Undersigned begs to report that the construction of addition
on plot No. C/1 Sheet 223 Quarter owned by
Mr. C. H. S. R. S.
has been completed according to plans approved by the Municipal Corporation.
Orders are requested to file the correspondence.

In continuation of this office No. L. C. P. 497/37D/-4-8-38
~~With reference to your application dated~~
with a plan for the proposed buildings/additions and alterations on plot
~~XXXXXXXXXX~~
No. C/1 Survey Sheet No. J.M.3, Jamshed Quarter,
I have to request you to comply with the following requirements:-

1. Sweepers staircase within 10 feet compulsory open space cannot be allowed. These are also shown in the site plan
2. The built up area and measurements of the outhouses are not given
3. Plan requires correction as per structures constructed actually on site.
W.C under
4. Section of staircase adjoining garrage be given to make its details clear.
5. Staircase between the garrage and main building as shown in site plan with sides closed will have to be taken in built up area
6. Section requires correction.

PLAN & PROPOSED ADDITION & FIRST
ON PLOT NO. 41 J.M.2. JAMSHED PUR
COSMOPOLITAN HOUSING SOCIETY.
SCALE 8 FT TO AN INCH.

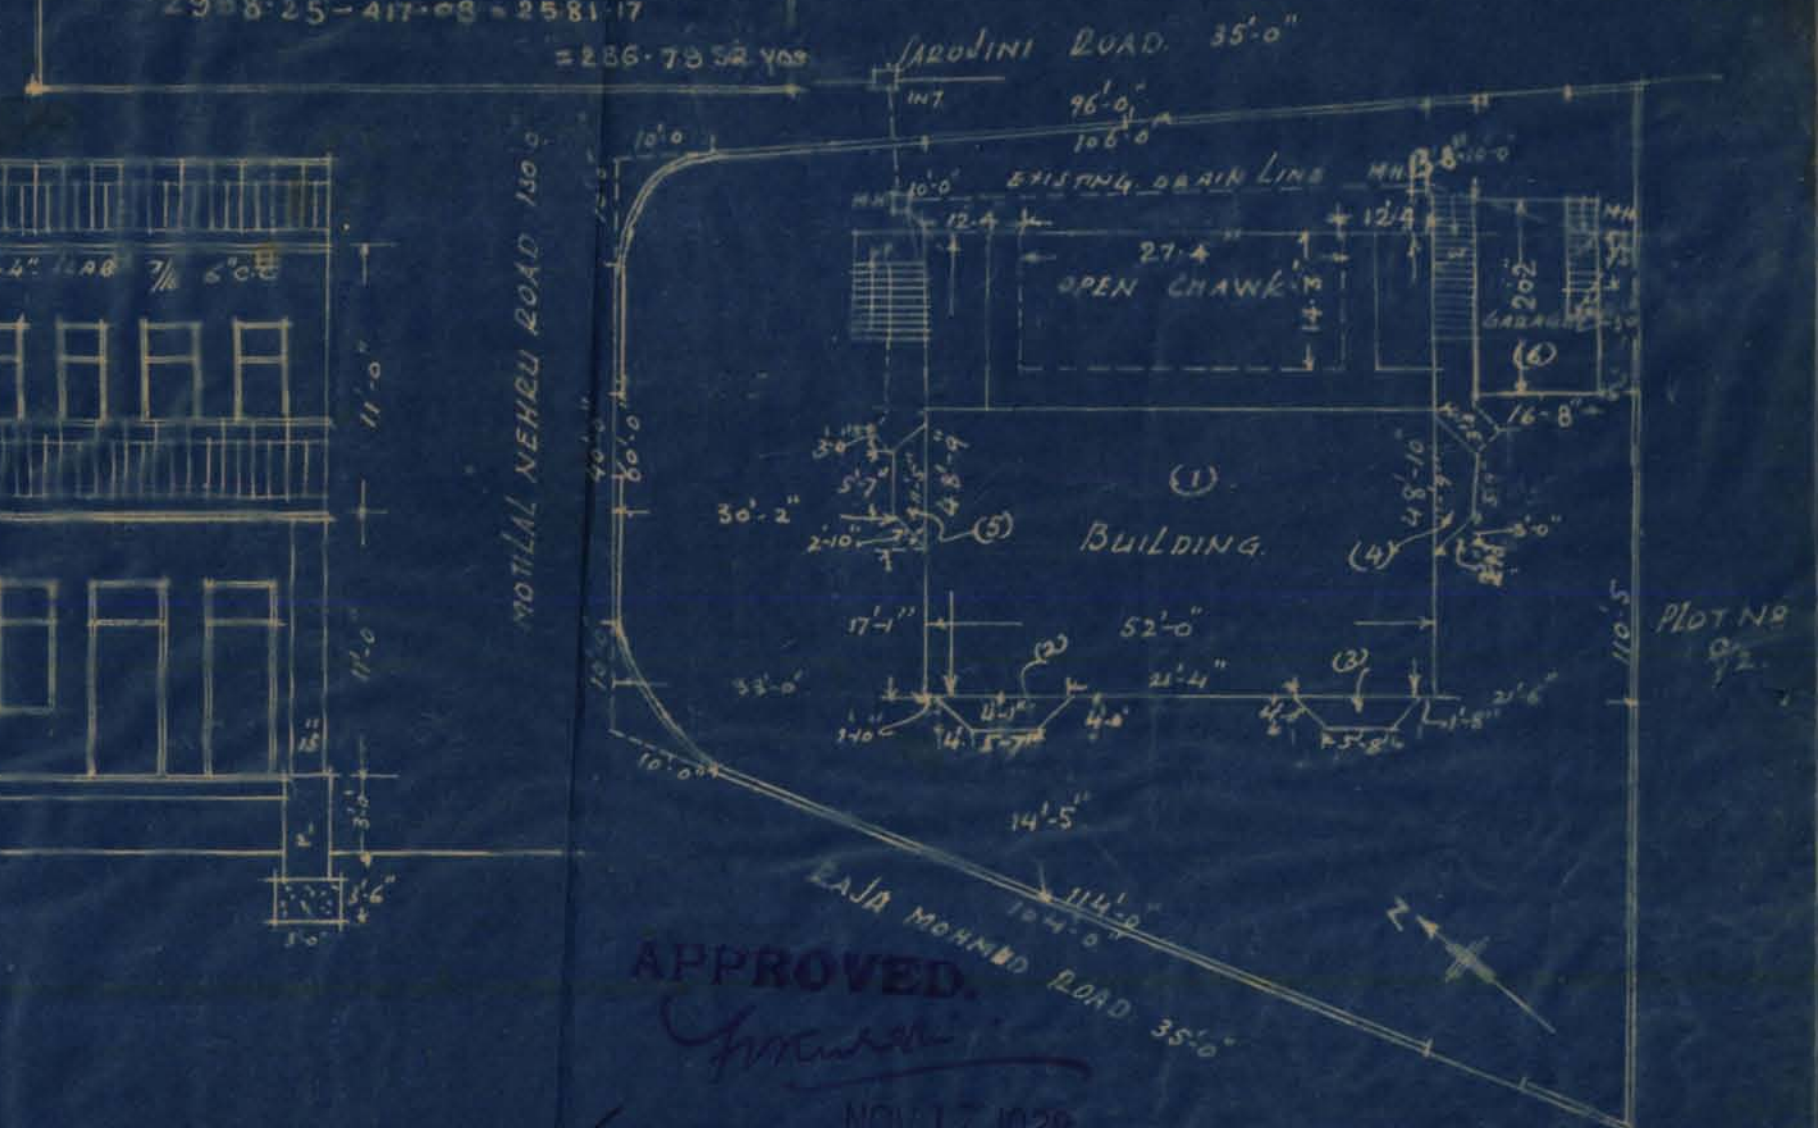
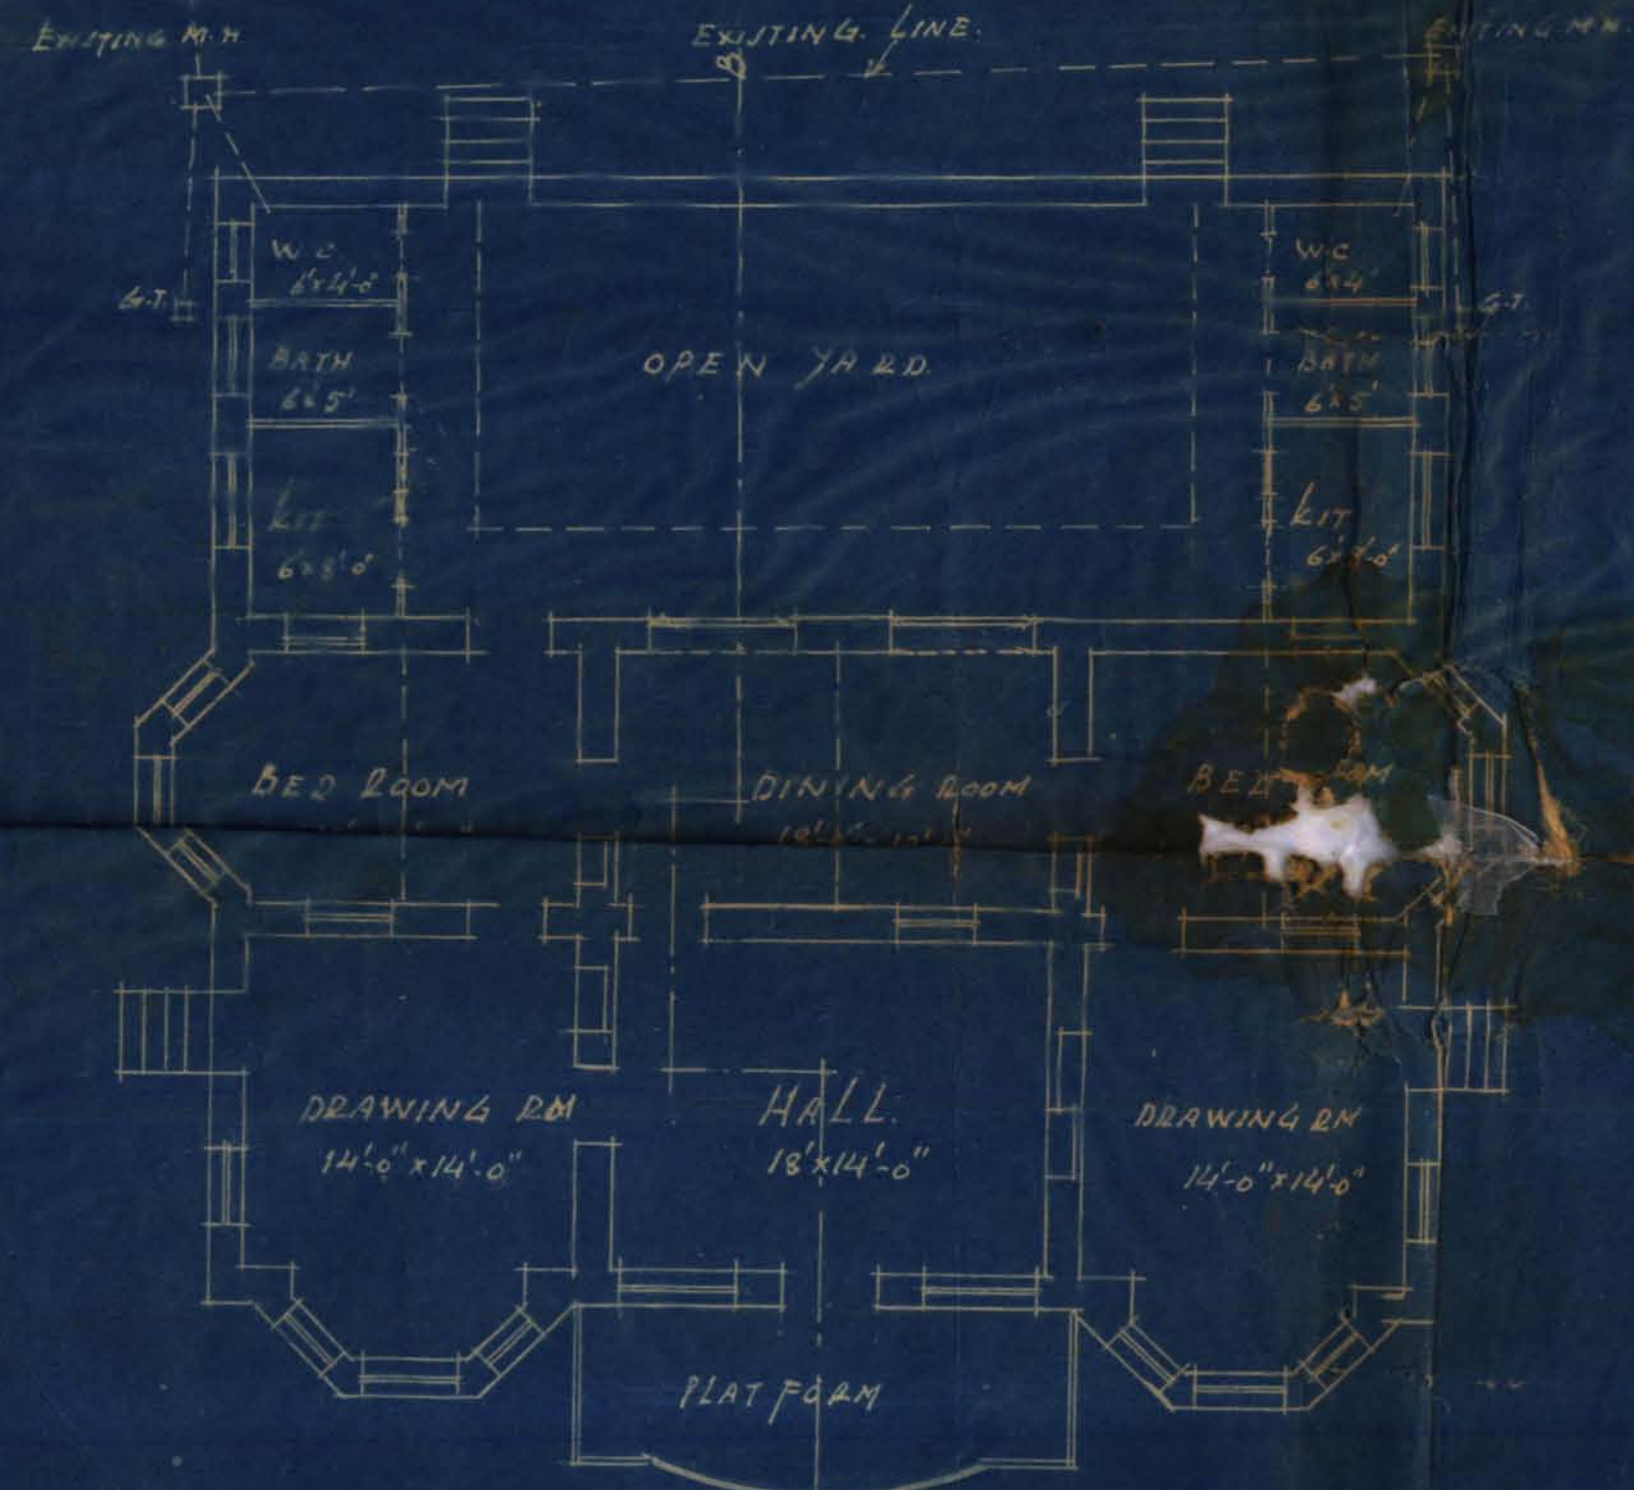
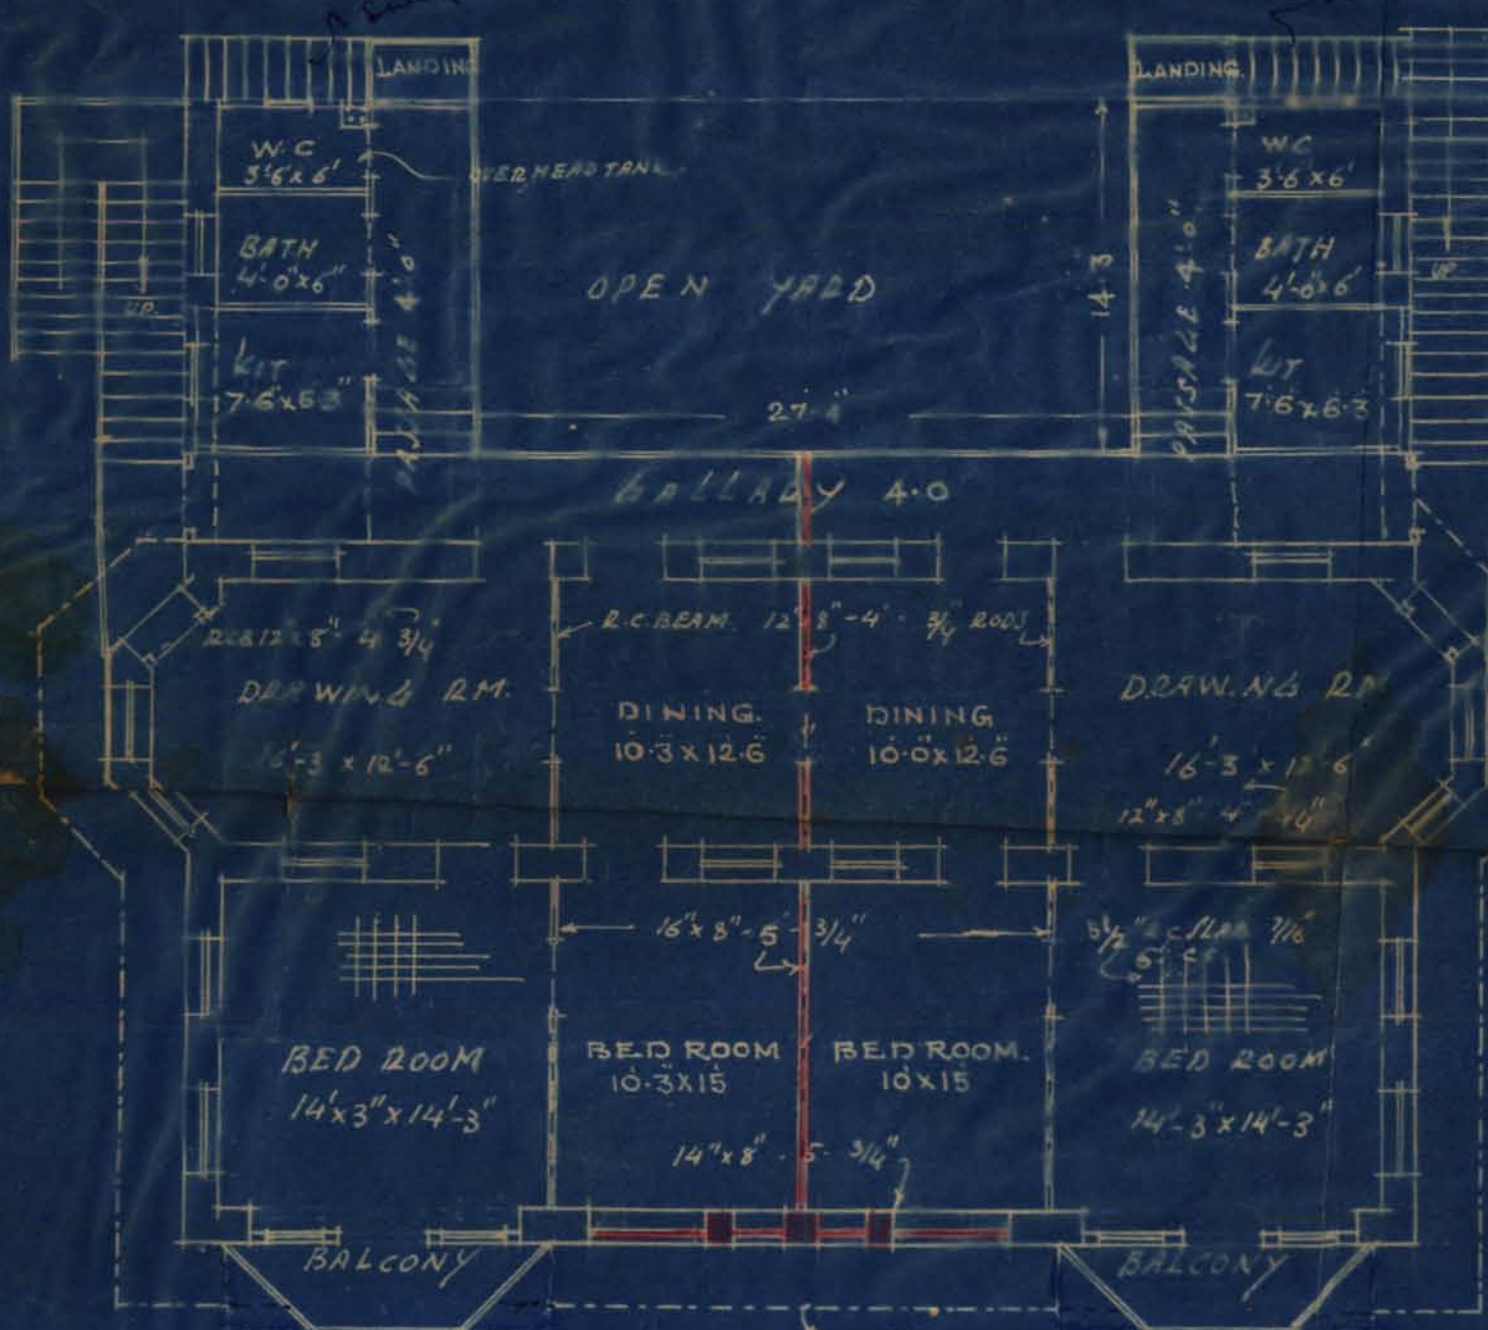
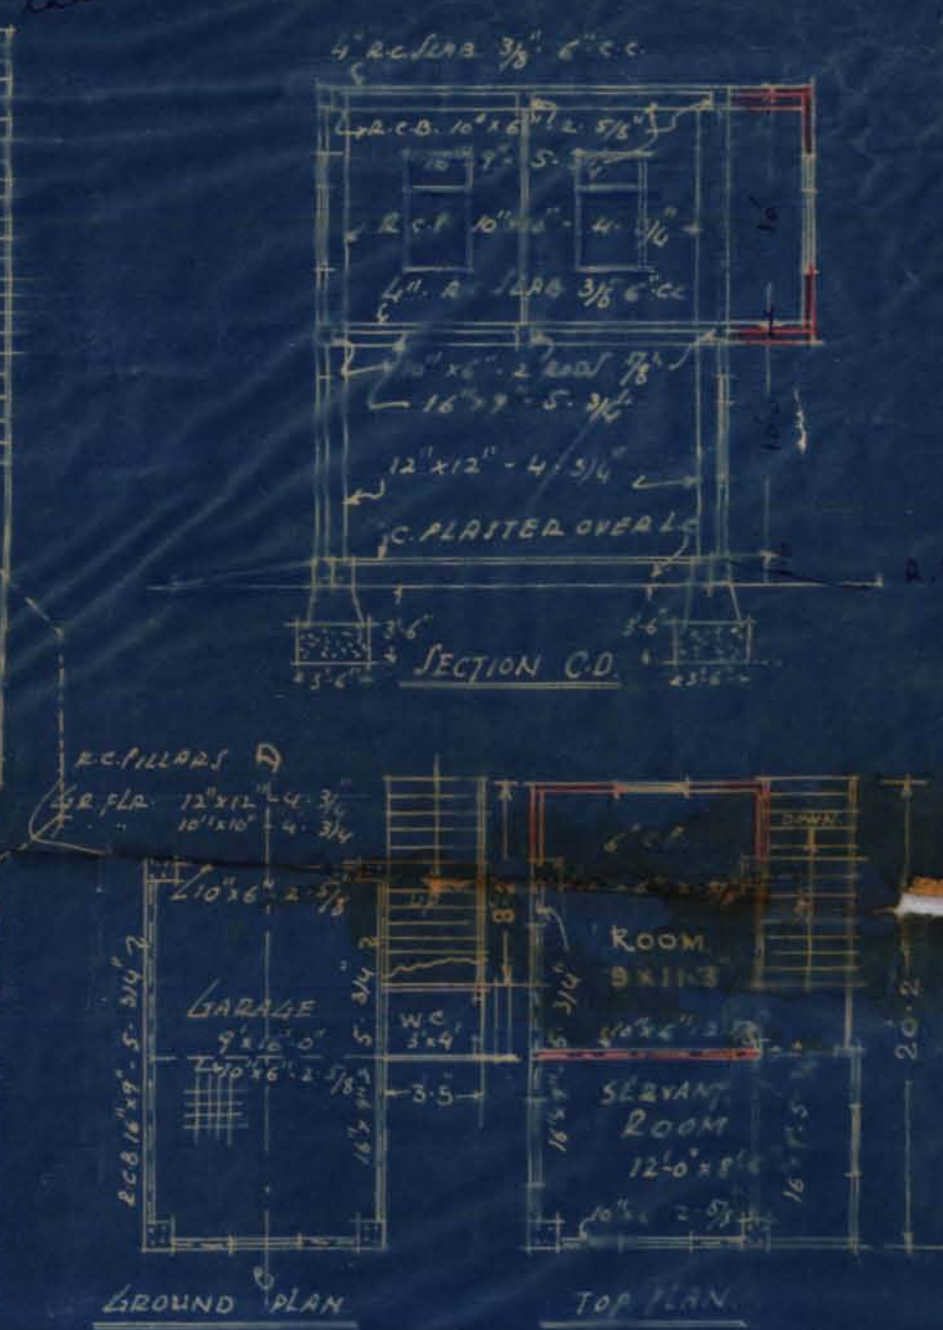
*Submitted to C.O.
the proposed staircase marked
A. Comply within 10' compulsory open space.
the owner claims to retain the
staircase on submission of agreement
as done in other cases.*

The ~~XX~~ Sweepers staircase should be removed.

1. Sweepers slain cars within 10 ft Compulsory open Can not be allowed. There are also not shown in the site plan.

2. The built up area & measurements of the out-houses are not correct.

3. Plans require corrections as for structures constructed actually on site.

4. Section of the W.C. under staircase adjoining garage
be given to make its details clear.

5. Plan care between garage & the main building as shown in site plan with ~~and leaving open space~~ sides could will have to be taken in built up area.

6. Section requires correction Shu 913

- (1) Sweepers staircase are proposed as removable lattice, there is only one ladder on the north end which comes in 10" space. The usual agreement may please be taken if desired.
- (2) Built-up area & measurement of out house are given.
- (3) Plans are corrected per structure on site.
- (4) Section of W.C. has been given.
- (5) Staircase between garage & main building has been taken as built-up area.
- (6) Section has been corrected.

The Sweepers staircase should be shown on the site plan and usual agreement should be executed
